BOARD OF APPEALS, CITY & COUNTY OF SAN FRANCISCO

Appeal No. **21-101**

NOTICE OF APPEAL

PRELIMINARY STATEMENT FOR APPEAL NO. 21-101

EXHIBIT 2

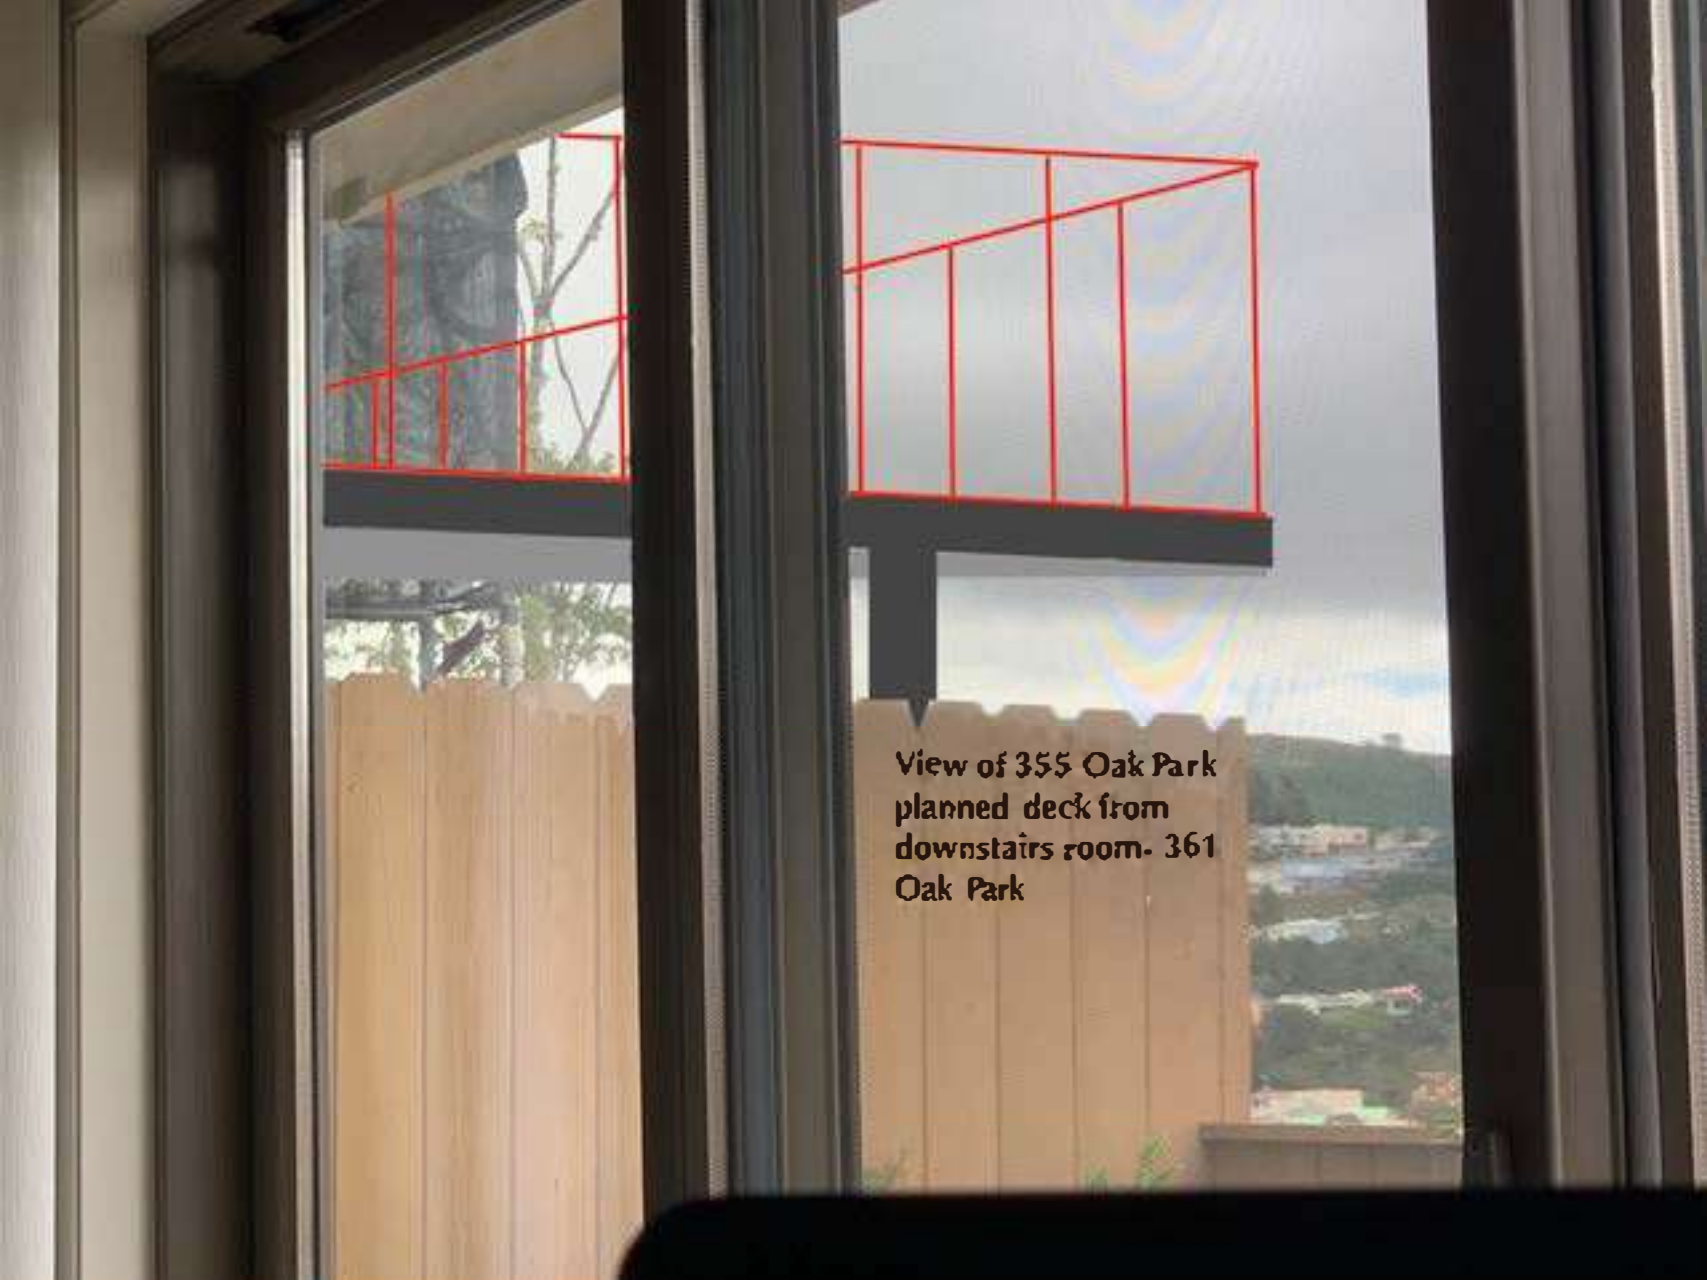
361 Oak Park-View from 355 deck will impact privacy to level 1 bedroom below as well as level 2 above. This will also impact 347 Oak Park the same way.

**View of 355
Oak Park
planned 10'
depth deck from
361 Oak Park .
Kay will lose
privacy in both
living and dining
rooms as well as
Vlad, who lives
on the other
side of 355 Oak
Park.**

**View of 355 Oak Park
planned deck from
downstairs room- 361
Oak Park**

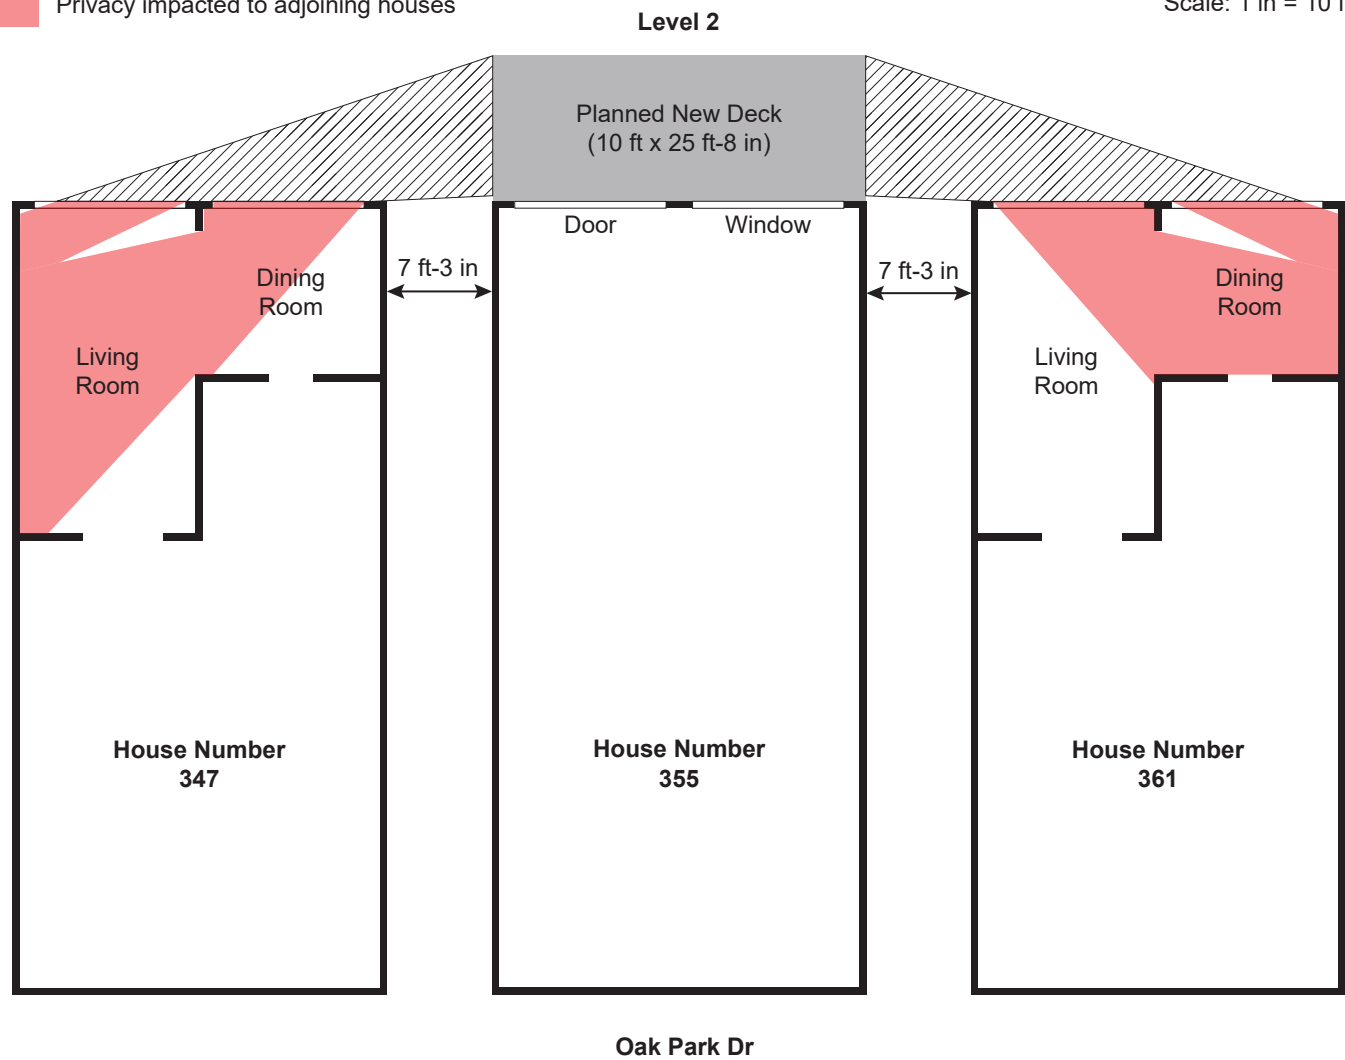
The proposed deck construction for the project creates impacts to the adjacent neighbor's privacy. Anyone standing on the proposed deck will easily be able to look into the adjacent homes' interior spaces facing onto the rear yards. The attached plan on page 3 shows the view angle from the deck and how easy it is to see into the interior private spaces of the neighbors.

We recommend that the deck be pulled at least 5 feet back from the side property lines, and that the deck be no deeper than 5 feet to improve privacy for both neighbors. Under no circumstance should the project design require any firewall requirement at the sides of the deck or the project must go through a formal neighborhood notification.
